ExG/COMP/2004/20
30 September 2004

Informal Ad hoc Expert Group on Conceptual and
Technical aspects of Computerization of the TIR Procedure
(26-27 October 2004)

Reference Model of the TIR Procedure

1.2 TIR Procedure domain

Figure 1.2 TIR procedure package diagram

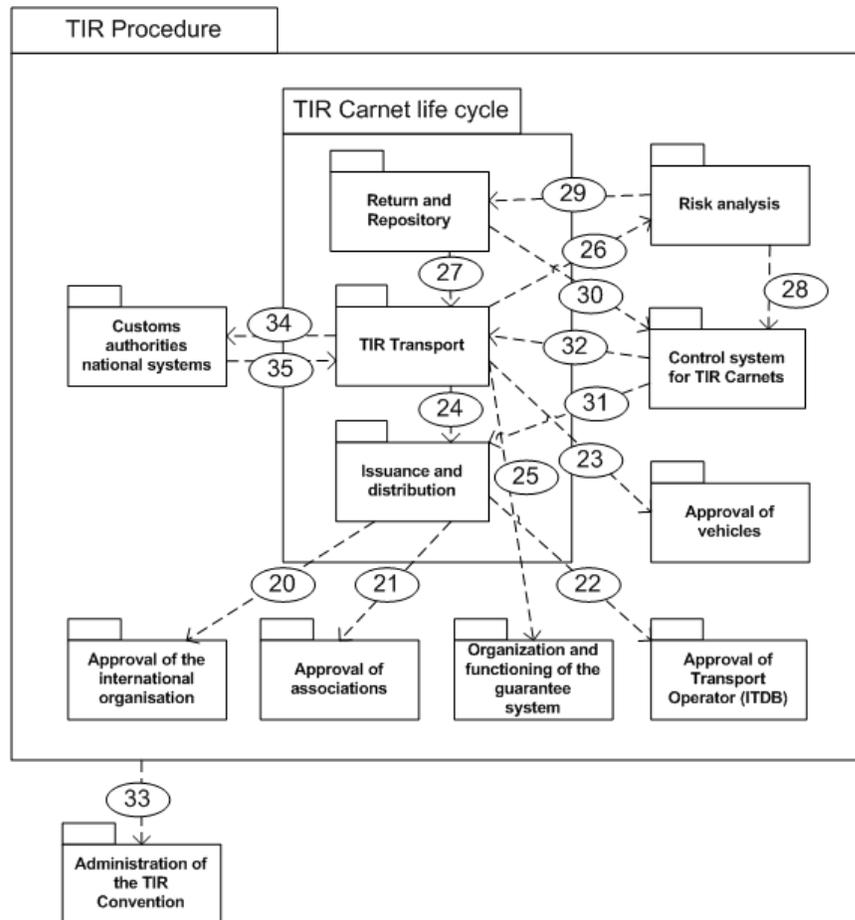
1. In the course of its work, the secretariat realized that national Customs authorities are missing from the TIR procedure package diagram and, as a consequence, raised issue 54. Following a discussion on the issue at its fifth session, the Expert Group requested the secretariat to present a revised Chapter 1.2 at its forthcoming meeting (ExG/COMP/2004/18, para. 7 / Decision 71).

Name	TIR procedure package diagram
Description	<p>The TIR procedure is an International Customs Procedure governed by the TIR Convention, 1975. A detailed description of the procedure can be found in the introduction of the TIR Handbook distributed by the TIR Secretariat.</p> <p>The TIR procedure is composed of numerous interconnecting systems to allow for the functioning of the procedure. The system we are most interested in for the current project is the TIR Carnet system. It can be defined by listing all functions and uses of the TIR Carnet. It is composed of sub-systems, namely: the issuance and distribution system, the TIR transport system and the return and repository.</p> <ul style="list-style-type: none"> • The function of the issuance and distribution sub-system by the international organization and the national associations is to provide transport operators with TIR Carnets in order to allow them to perform TIR transports; • The TIR transport sub-system is the central system of the TIR procedure. It links the transport industry to the customs offices involved in a TIR transport and allows them to exchange the necessary information; • The transport operators, the associations and the international organization manage the return and repository sub-system. Its function is to centralize the storage of the used TIR Carnet and to check that no problems have occurred during the TIR transport; <p>Other systems outside the scope of the current project but of importance for the well functioning of the TIR procedure are:</p> <ul style="list-style-type: none"> • Customs authorities national systems; • Approval of the guarantee chain; • Approval of the association; • Approval of transport operators; • Approval of vehicles; • Control system for TIR Carnets; • Organization and functioning of the guarantee system; • Risk analysis system; • Administration of the TIR Convention. <p>In the package diagram, the dependencies between all systems are indicated with dashed arrows. The dependencies are numbered according to the Requirements 20 to 35 of which they are the consequences.</p>

Req. #	Statement	Source	Date	Status
34	All through the TIR transport, national Customs authorities need the information in the TIR Carnet to feed their national systems.			Used in 1.2.1
35	All through the TIR transport, national Customs authorities need data from their national systems to feed the TIR Carnet.			Used in 1.2.1
